No. INF 11/01

Products Manuals Dissolved Oxygen Monitors

Converting from 9435 Transmitter to a 9438 Transmitter

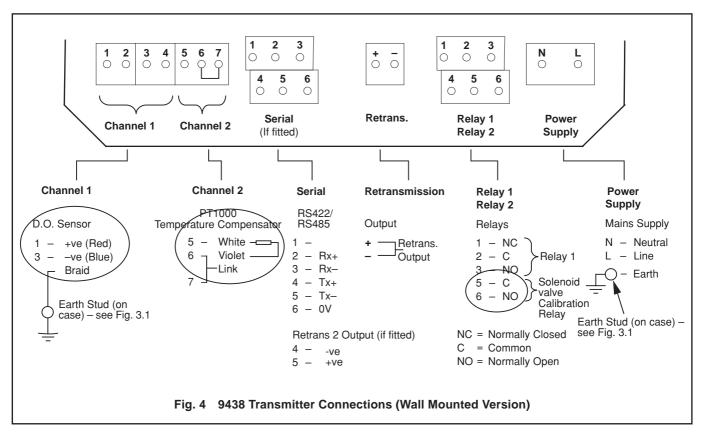
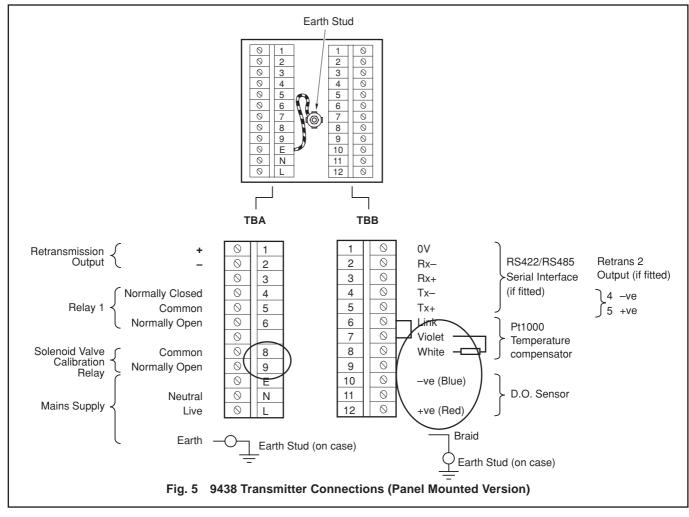
- Cut the wires in the 9435 sensor junction box as shown in Fig. 2. See Fig. 1 for location. Fit cable gland as indicated.
- Disconnect the wires from the 9435 transmitter as shown in Fig. 3 and discard the transmitter. Cut back the wires indicated.
- Wire the free end of the cable into the 9438 transmitter as shown in Figs 4 and 5 (as appropriate) not forgetting the braid.
- 4) Using a length of 3-core cable, connect as indicated in the diagram in Fig. 6. Further details of the power supply unit can be found in **Appendix A** of the 9438 Instruction Manual.

Fig. 3 TB3 in the 9435 Transmitter Unit

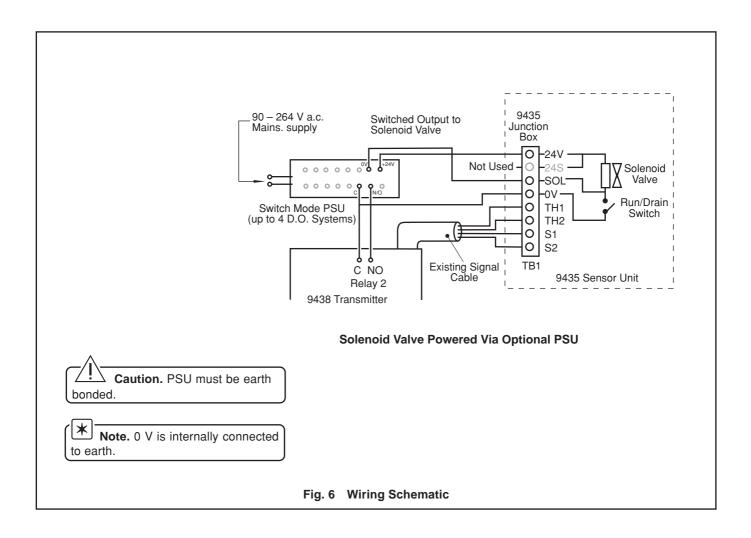
Disconnect all these wires from TB3 on the 9435 transmitter.

Cut back the black, brown, yellow and green wires.
